## PLANNING COMMISSION STAFF REPORT

June 19, 2025

**APPLICATION:** Planning File No. MODSP-25-0002: Modification adjustment to MAJ-23-0007

**LOCATION:** 602 Galena / Lots 13 through 21, Block 3, Frisco Townsite

SOUTH ELEVATION - PERMIT SET (04/10/25)

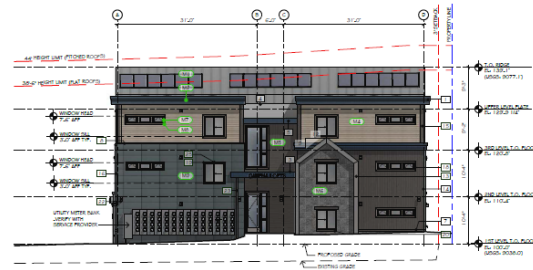
Additional updates include the replacement of black aluminum windows with almond vinyl windows and the incorporation of the panel accent siding. Additional architectural modifications are illustrated in the elevation comparisons below. Per the applicant, the modifications are intended to improve façade articulation and material integration based on Planning Commissioner feedback.

Each elevation uses at least four (4) articulation techniques as required, including deep eaves and overhangs of 24 inches or more, balconies and decks on multiple levels, and sheltering elements such as covered entries and porches. The façades also feature offsets and varied wall planes, material variation including diverse siding and trim details (as noted in materials M1–M9), roof plane variation with articulated gables and dormers, and a variety of window sizes and shapes, with sills set at multiple heights. These design techniques are consistently applied on the north, south, east, and west elevations, but are not deemed duplicative. The revised Application shows greater articulation in the architectural elements than the previously approved Final Site plan.

As stated above, the Application uses design techniques that are consistently applied on the north, south, east, and west elevations, but are not deemed duplicative. The revised Application shows greater articulation in the architectural elements than the previously approved Final Site plan.
